Log # TXX-89577
File # 10010
908.3
Ref. # 10CFR50.34(b)

SUBJECT: COMANCHE PEAK STEAM ELECTRIC STATION (CPSES)
DOCKET NOS. 50-445 AND 50-446
ADVANCE FSAR SUBMITTAL
UPGRADE AND ADDITION OF CLASS 1E ELECTRICAL
EQUIPMENT IN THE PRIMARY PLANT VENTILATION
SYSTEM TO MAINTAIN NEGATIVE PRESSURE

Advance FSAR Change Regarding the Upgrade and Addition
of Class 1E Electrical Equipment in the
Primary Plant Ventilation System
to Maintain Negative Pressure

FIG. 8.3-9 SHEET 1

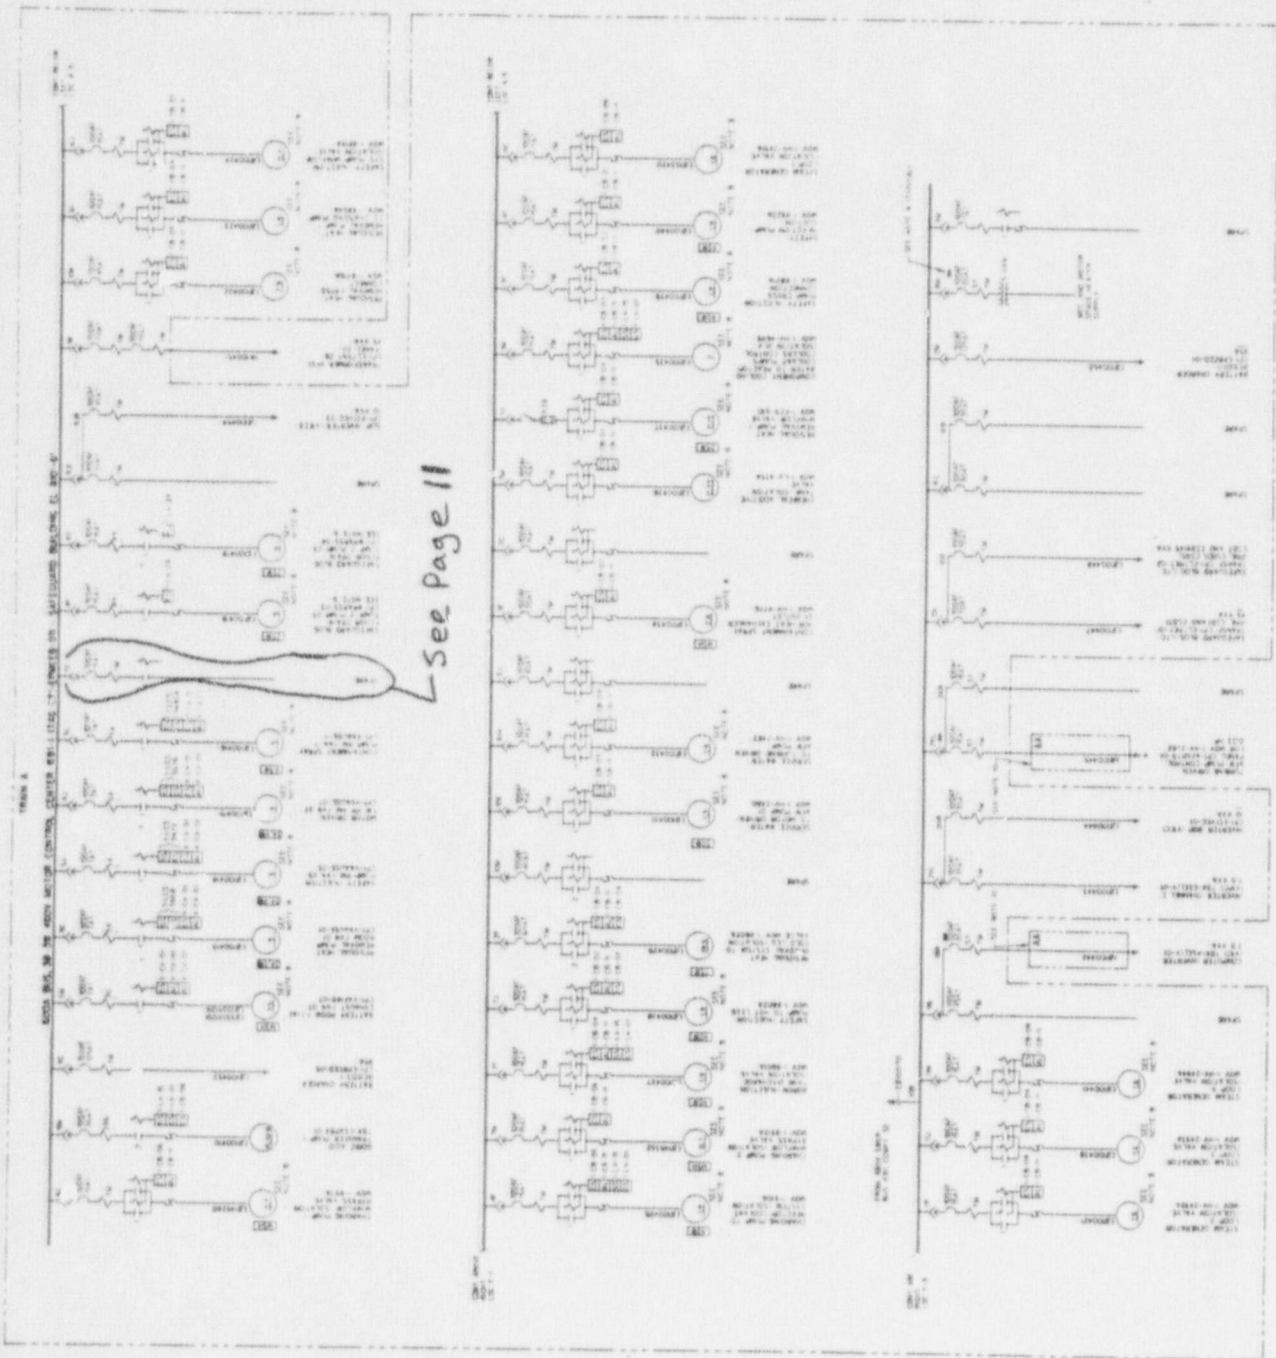
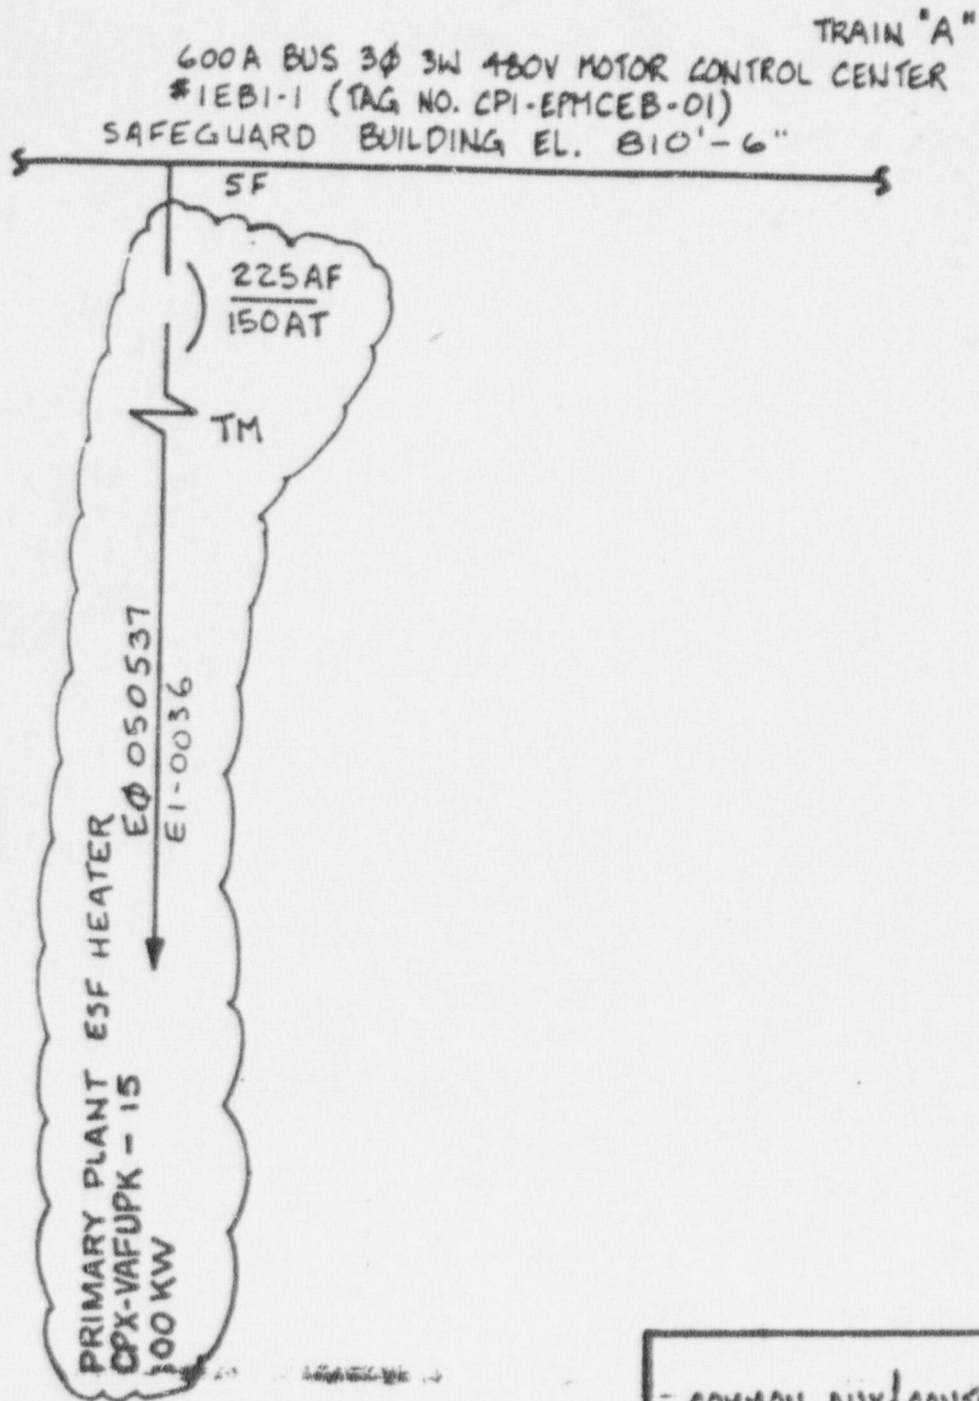
- 2 See Sheet No(s):1
Adds Primary Plant ESF Heater (CPX-VAFUPK-15), Class 1E power cable, and circuit breaker to 480V MCC 1EB1-1, Compartment 5F.
Revision:
The Primary Plant Ventilation System has been modified by adding two Primary Plant ESF Heaters, Class 1E power cables, and circuit breakers. The purpose of this modification is to provide additional heater capacity to ensure a maximum of 70% Relative Humidity within the ESF Air Filtration Units.
FSAR Change Request Number: 89-528.1
Related SER Section: 8.3.1
SER/SSER Impact: No

FIG. B.3-9 SHEET 3

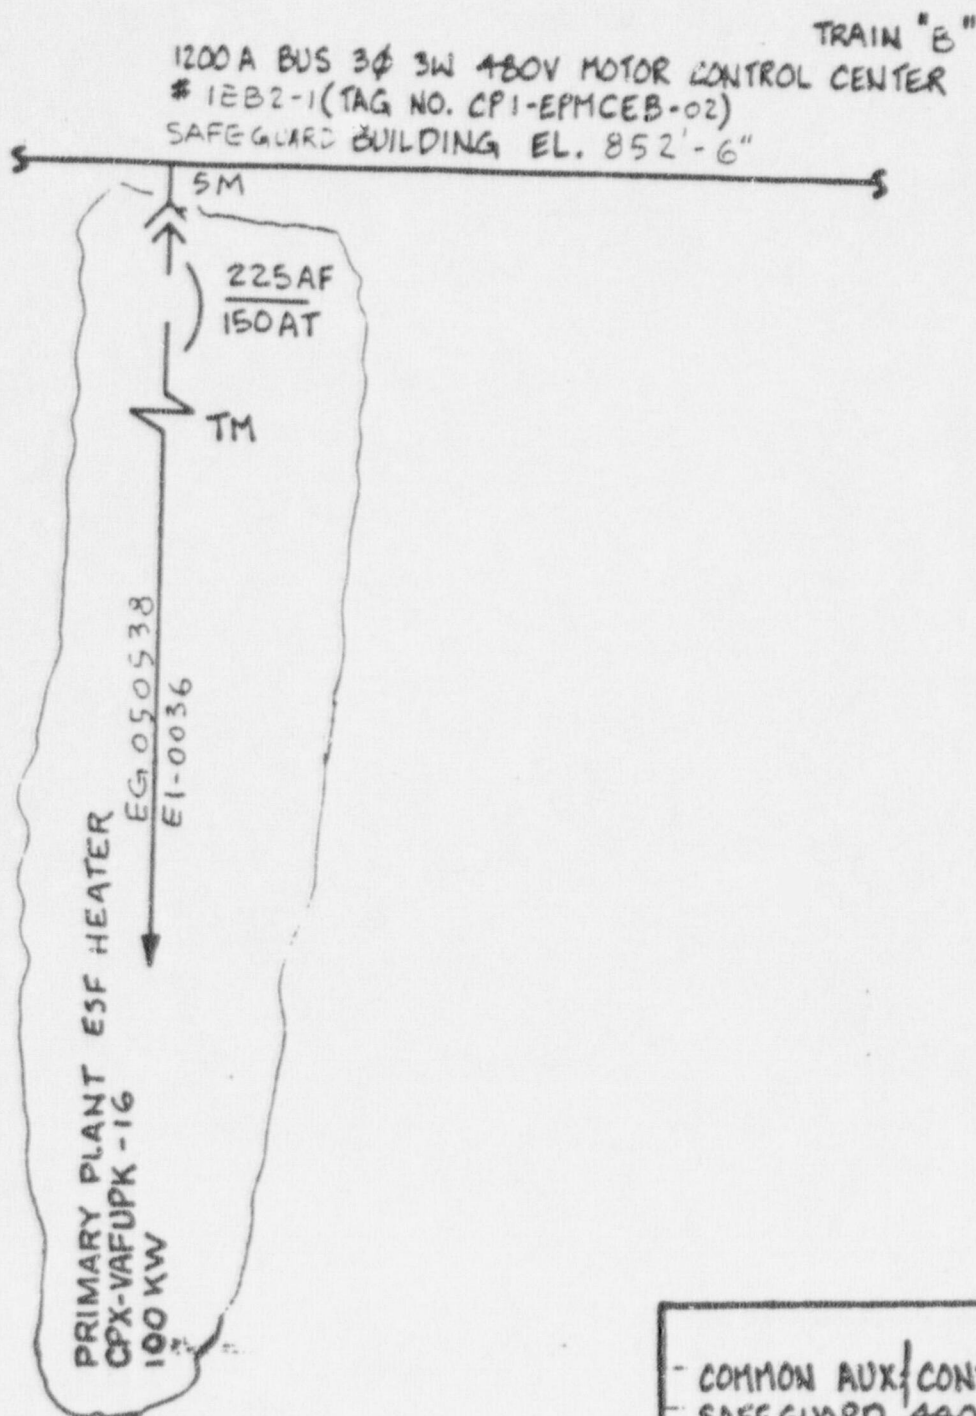
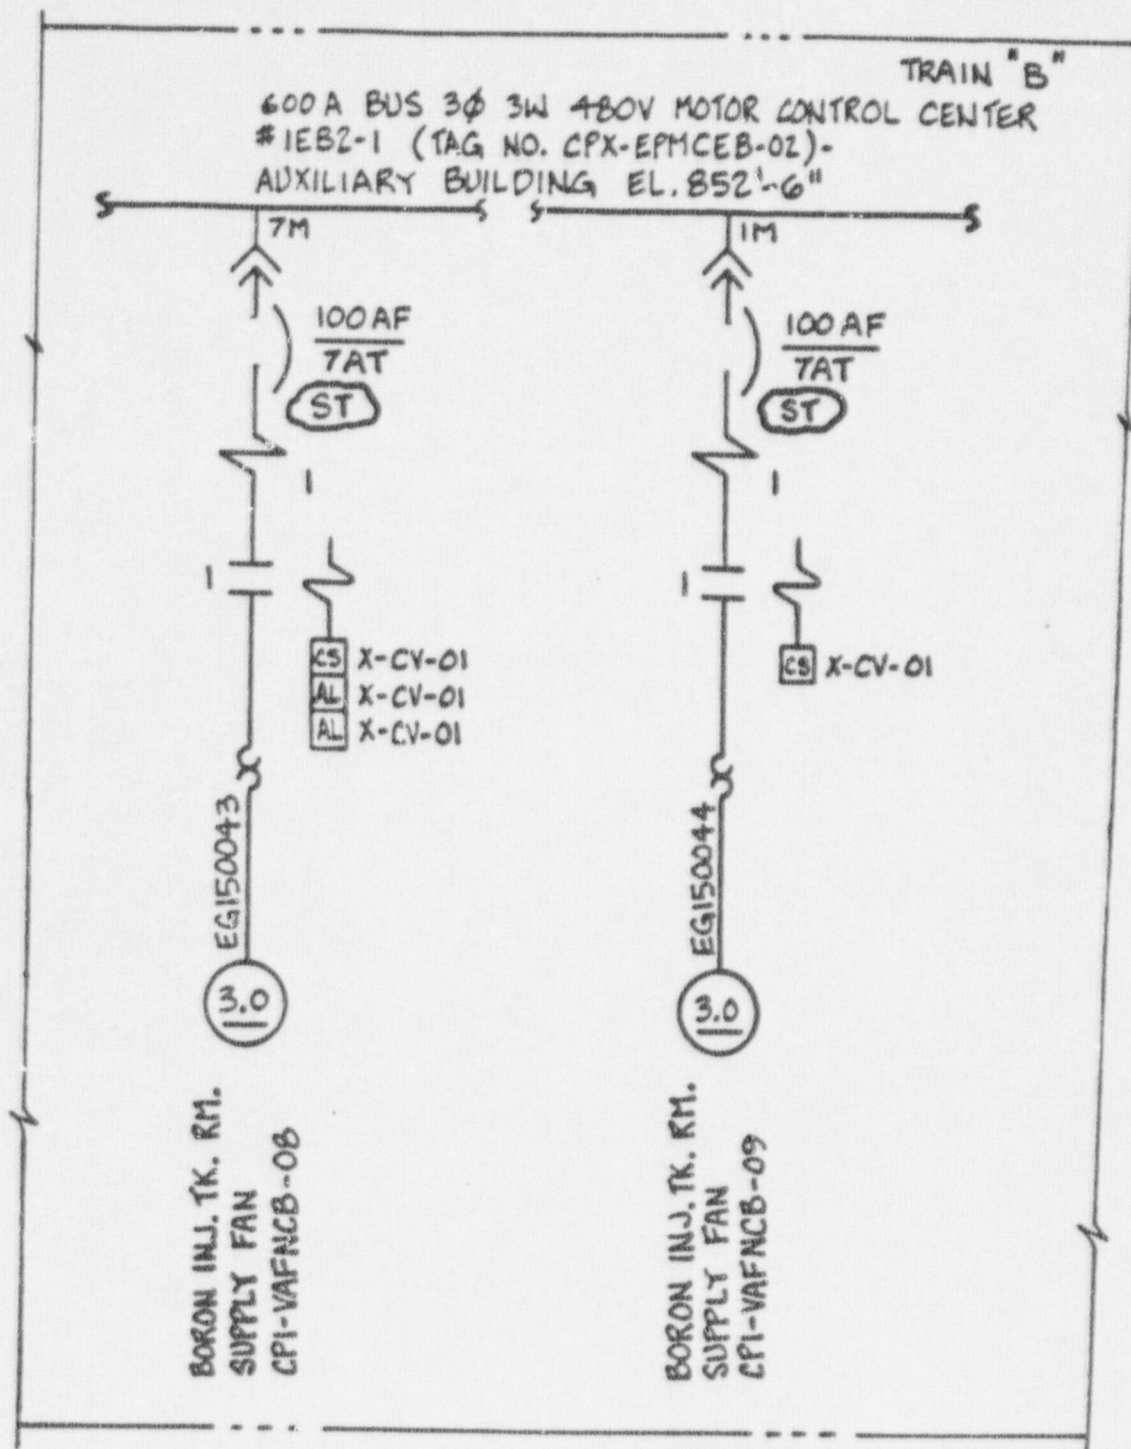
- 2 See Sheet No(s):3
Adds Primary Plant ESF Heater (CPX-VAFUPK-16), Class 1E power cable, and circuit breaker to 480V MCC 1EB2-1, Compartment 5M.
Revision:
The Primary Plant Ventilation System has been modified

- 3 See Sheet No(s):3
Adds "S" signal trip to the breaker associated with each Boron Injection Tank Room Supply Fan (CP1-VAFNCB-08, 09) in Compartment 7M and 1M of 480V MCC 1EB2-1, respectively.

by adding two Primary Plant ESF Heaters, Class 1E power cables, and circuit breakers. The purpose of this modification is to provide additional heater capacity to ensure a maximum of 70% Relative Humidity within the ESF Air Filtration Units.
